Environmental Planning Commission

Staff Report

Agenda Number: 01
Project #: PR-2020-003455
Case #: SI-2020-00051
Hearing Date: April 23, 2020

Agent	Consensus Planning, Inc.
Applicant	Dynamic Investors
Request	Site Plan
Legal Description	Tract B-3-A Plat of Tract B-3-A KOA Subdivision Unit 2
Location	540 Paisano St. NE
Size	5.1 acres
Existing Zoning	PD

SITE PLAN

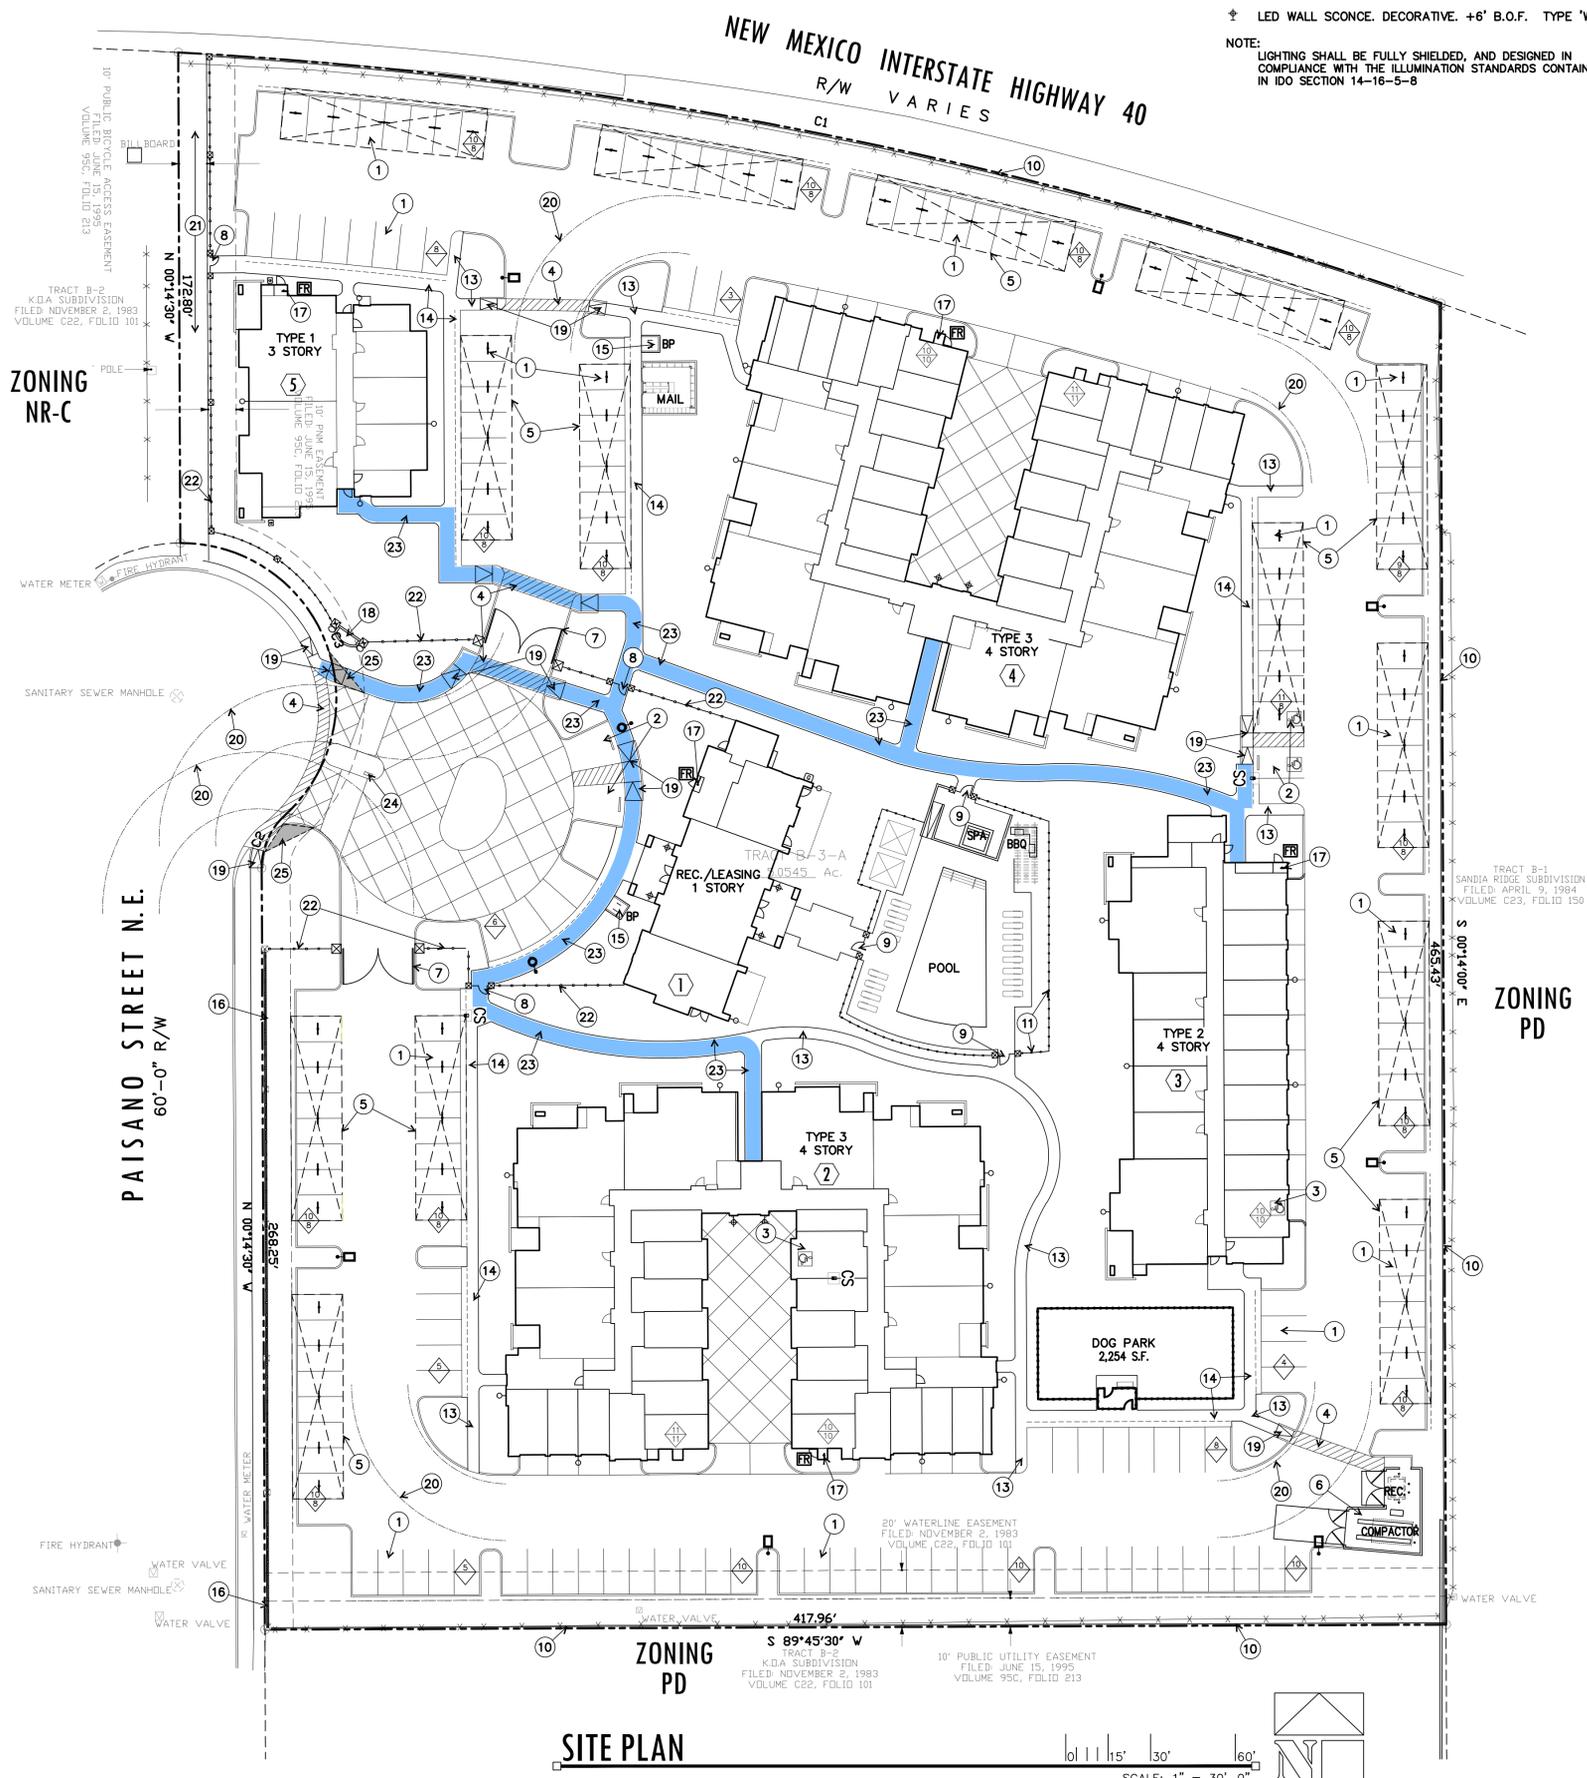
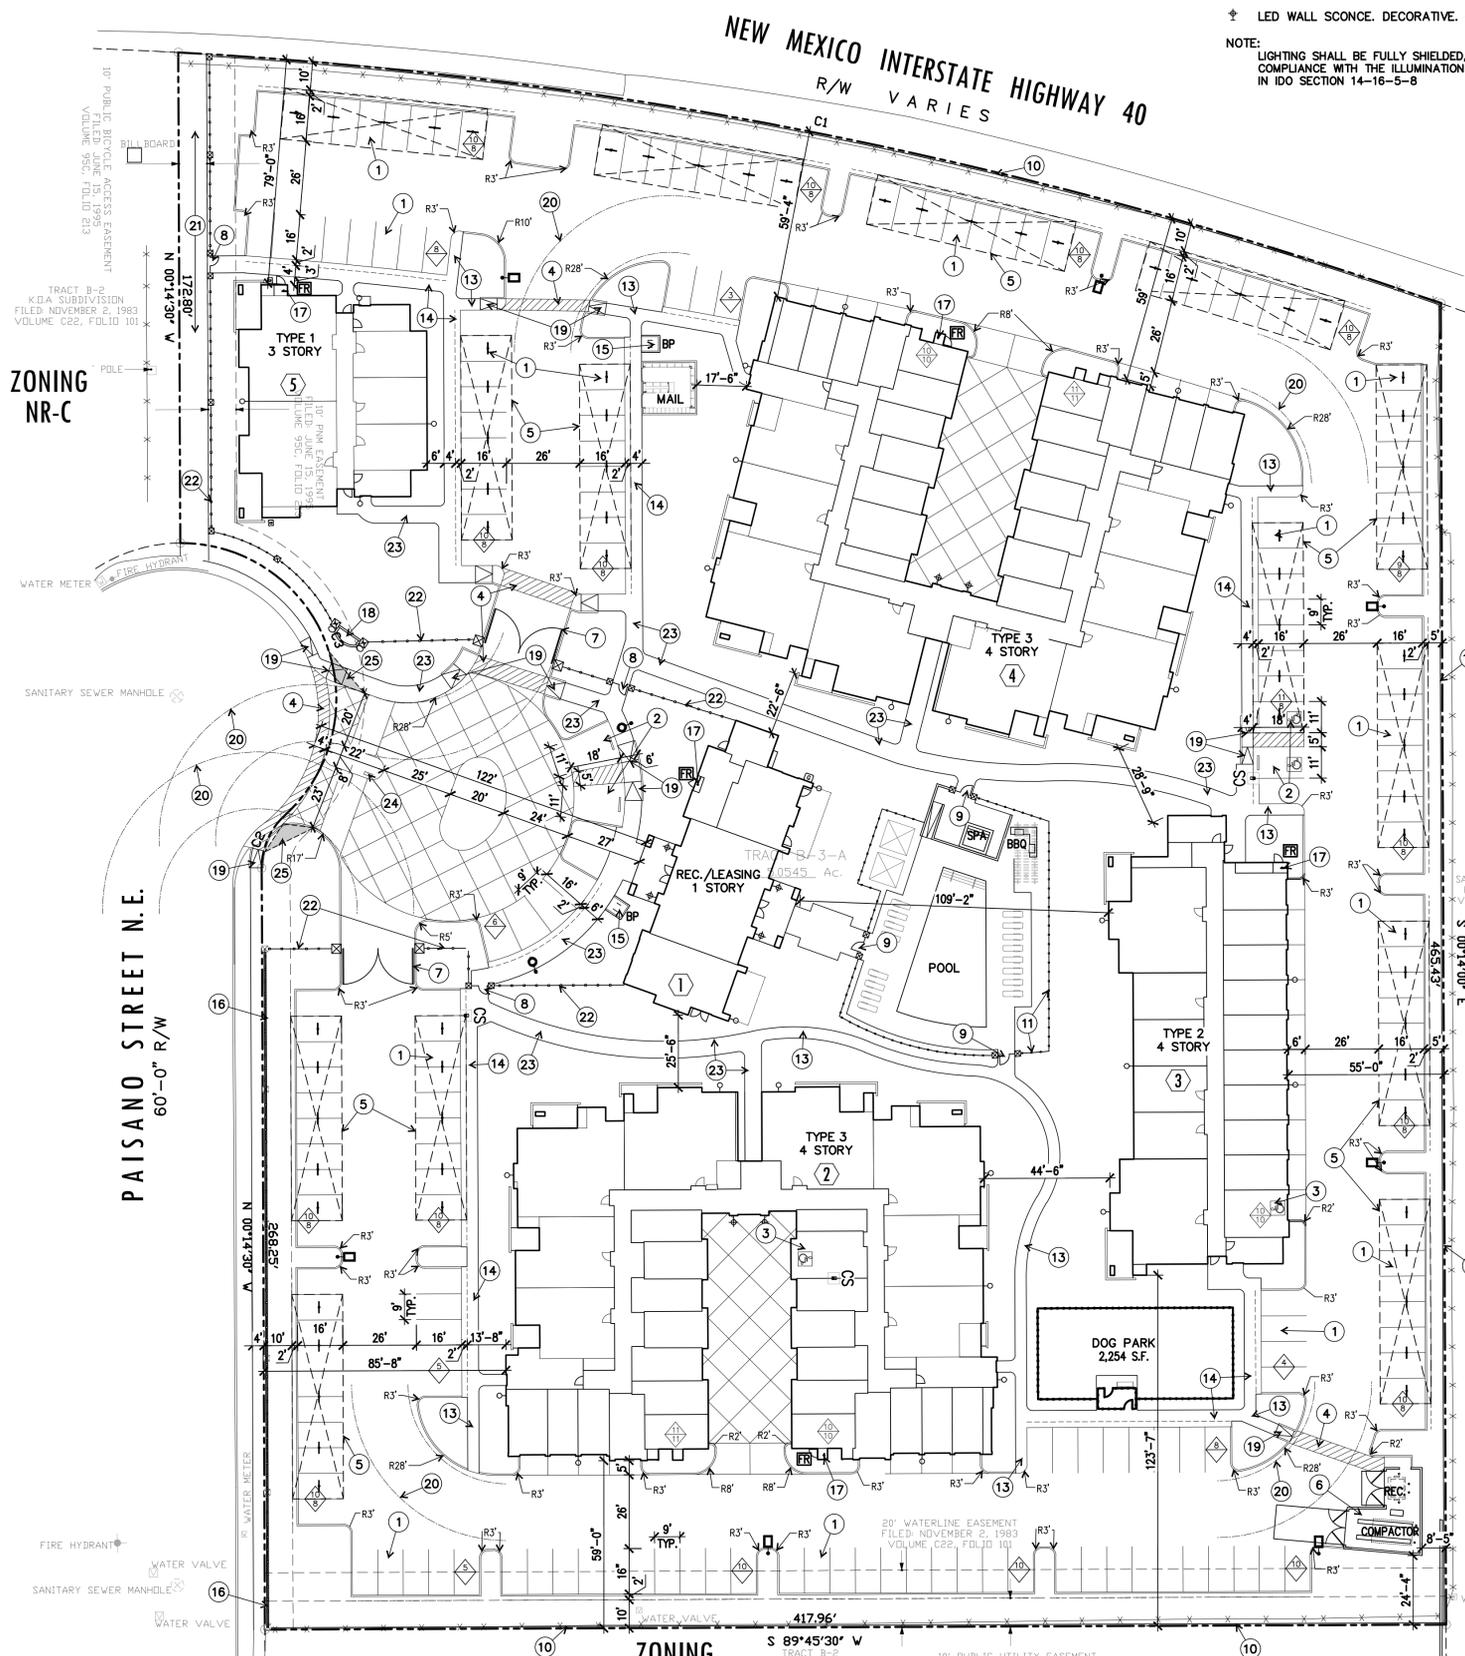
18. IDO criteria 5-5 Parking and Loading is not sufficiently met as garages are calculated as bicycle parking spots. It is recommended that bicycle racks be provided at each building to provide another 17 spaces (as a minimum), and not only at the pool area.

Project #2020-003455 – Tree located next to new proposed refuse enclosure on sheet LS-101 needs to be relocated or removed so it will not hinder service to the compactor.

Light that is located next to new proposed refuse enclosure on sheet A1.10 needs to be relocated or adjusted so it will not hinder service to the Compactor. New proposed refuse enclosure, concrete pad and apron and bollards must meet COA Solid Waste Department Minimum requirements.
